AMENDMENTS TO
James City Service Authority Design and Acceptance Criteria for Water Distribution and
Sanitary Sewer Systems March 2021 Edition
Amendment date – July 22, 2021

DWG NO. GP1.0
 SCALE: NONE
 DATE: 4-2017

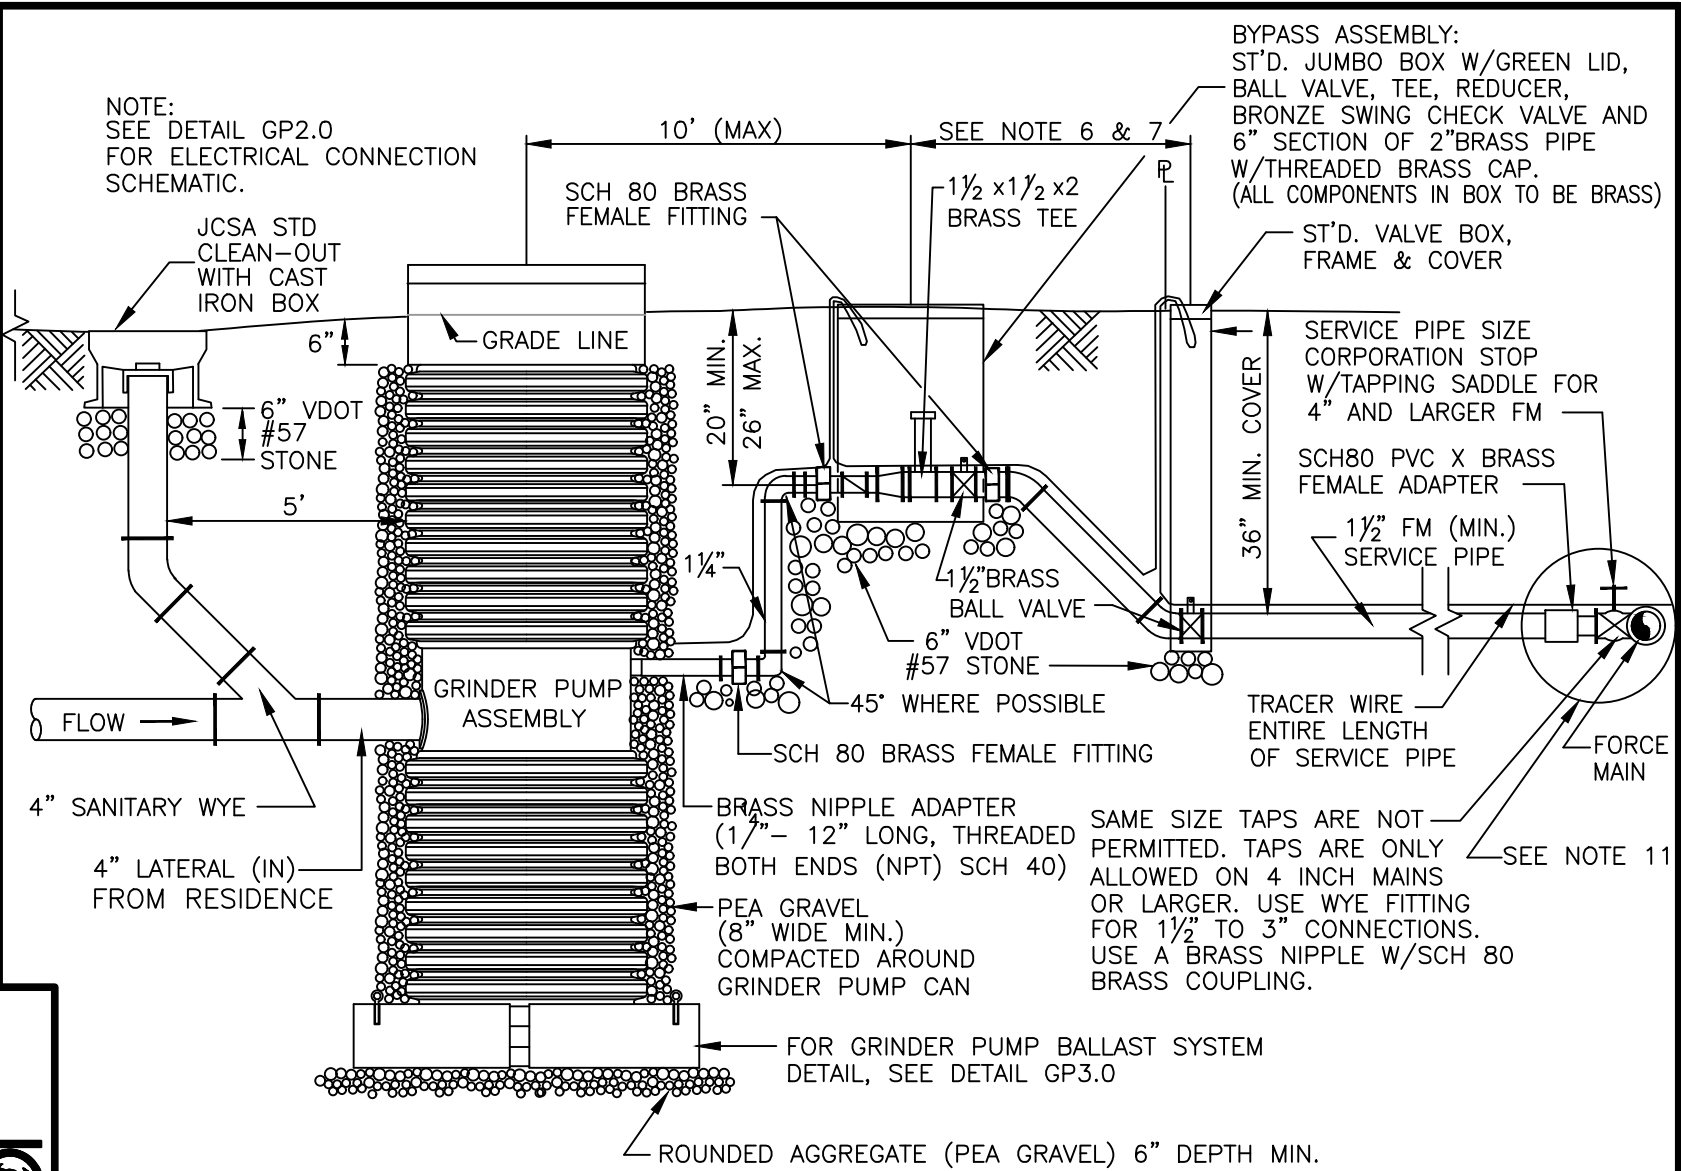
2. Appendix B, JCSA Standard Details, DWG NO. GP-01 Page 1, replace with revised drawing included as part of this amendment
3. The following details, provided as part of this amendment, shall be added to Appendix B:
 - a. Detail JR1.1 – Joint Restraint Table for Polywrapped Ductile Iron Pipe
 - b. Detail JR1.2 – Joint Restraint for Ductile Iron Pipe

REVISION DATE	COMMENT
11/12/2020	ADDED REFERENCE TO NOTE 11
5/17/2021	ADDED ADDITIONAL JUMBO BOX NOTES
